RANCHO APARTE SUBDIVISION

APPLICATION NUMBER 6 DATE October 19, 2017

REQUEST Subdivision

DETAIL SITE PLAN

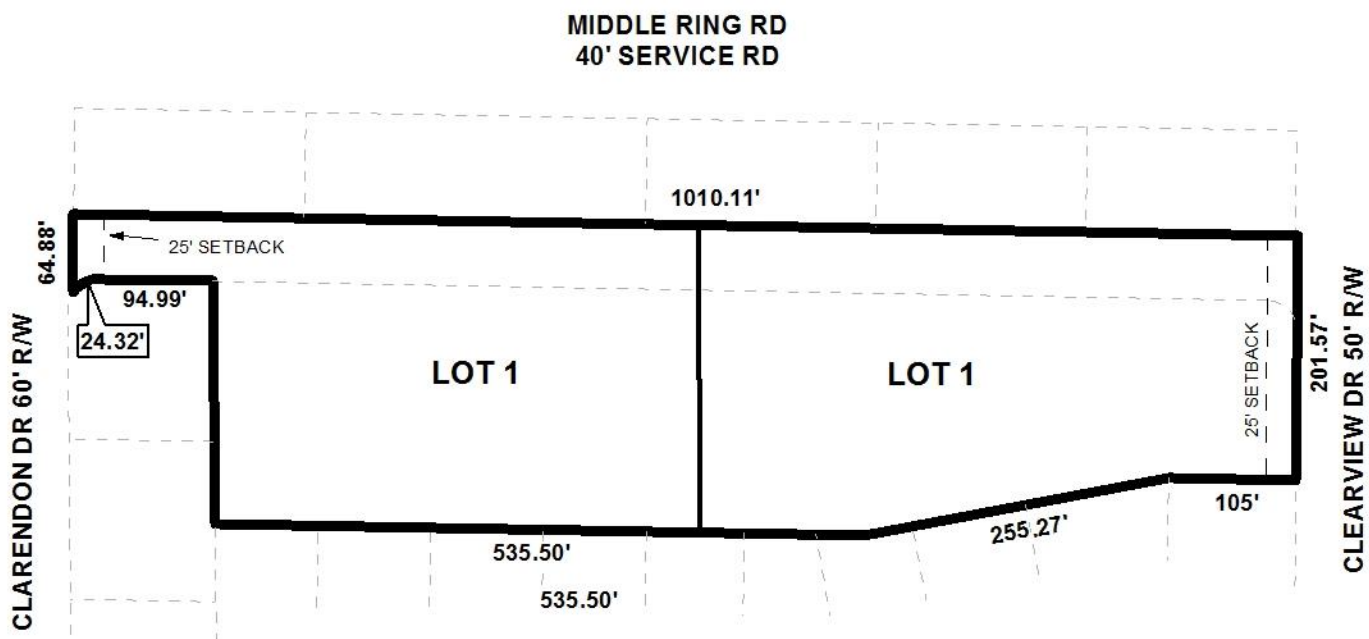
The preliminary plat depicts two proposed lots, each labelled as "Lot 1." The plat should be revised to differentiate the names of each lot.

The existing parcel is irregular-shaped in its current configuration, as the parcel exceeds the width to depth ratio of Section V.D.3. of the Subdivision Regulations. The proposed lot configurations still create irregular-shaped lot conditions in which the proposed west Lot 1 along Clarendon Drive forms a "panhandle" or "flag lot" shape. "Panhandle" or "flag lot" shaped lots are generally not allowed, but permitted only in those locations where varied and irregularly shaped lot designs are common and the informality of design is consistent with other lots in the vicinity; or where unusual circumstances such as an odd shaped lot exists; or separate disparate uses exist on a single lot; or where there are natural or pre-existing man-made barriers which may cause an undue hardship on the land owner; or in the case of a family division. There are no flag lots located within the immediate vicinity of the proposed lots; however, due to unusual

circumstances and existing irregularities in the current parcel configuration caused by a previous requirement for a proposed major street, since removed from the Major Street Plan, a waiver of Section V.D.1. may be appropriate.

As a means of access management, a note should be placed on the Final Plat, if approved, stating that east Lot 1 is limited to one curb cut to Clearview Drive, and that the other west Lot 1 is limited to one curb cut to Clarendon Drive, with any changes to the size, design and location of the curb-cut to be approved by Mobile County Engineering and conform to AASHTO standards.

- 1) Renaming of the lots so that each lot has a unique name; i.e., "Lot 1" and "Lot 2;"
- 2) Retention of the 50' wide right-of-way width along Clearview Drive;

- 5) Retention of the lot size information in both square feet and in acres;
- 6) Placement of a note on the Final Plat stating that east Lot 1 is limited to one curb cut to Clearview Drive, and that the other west Lot 1 is limited to one curb cut to Clarendon Drive, with any changes to the size, design and location of the curb-cut to be approved by Mobile County Engineering and conform to AASHTO standards;
